ADDENDUM TO ADVERTISED CONTRACT

PROJECT NAME: TOWN OF BRASELTON 2021 LMIG ASPHALT RESURFACING PROJECT

PROJECT NUMBER: RFB #2021LMIG

AMENDMENT NUMBER: 1

TYPICAL SECTION

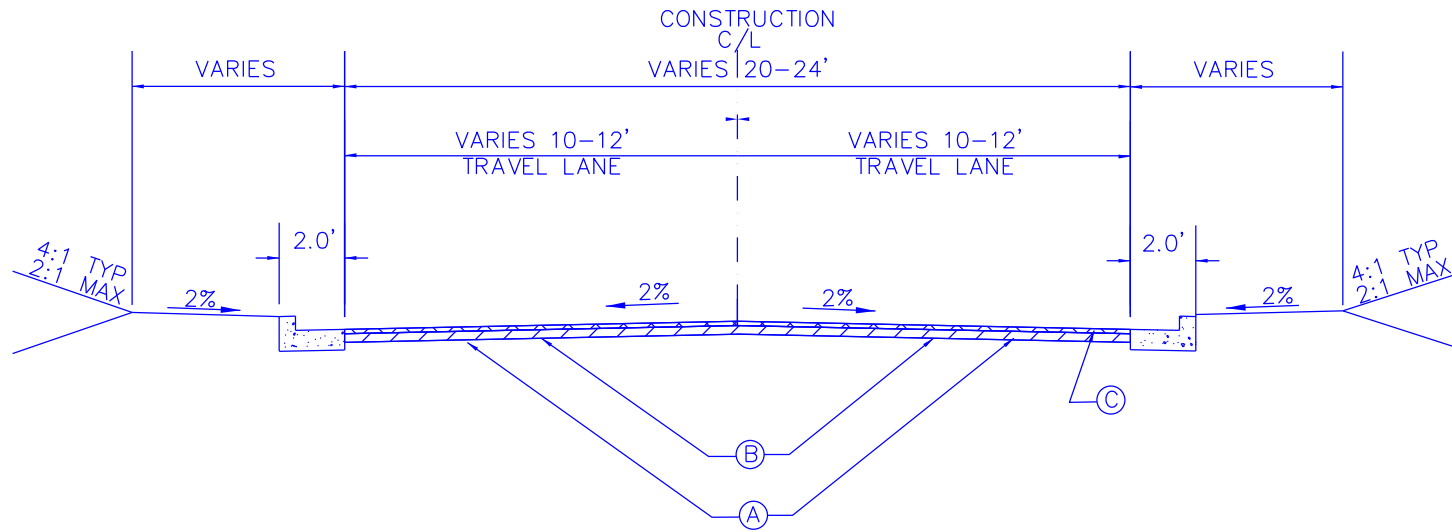
1. Add Bid Alternate #2 - Milling, Patching & Resurfacing of streets in the Mulberry Park Subdivision
 - a. See attached revised bid forms
 - b. See attached typical sections and location map

- A. MILL ASPH CONC, 3" DEPTH
- B. 220 LB/SY RECYCLED ASPHALT CONCRETE 19 MM SUPERPAVE OVERLAY
- C. 135 LB/SY RECYCLED ASPHALT CONCRETE 9.5 MM SUPERPAVE OVERLAY
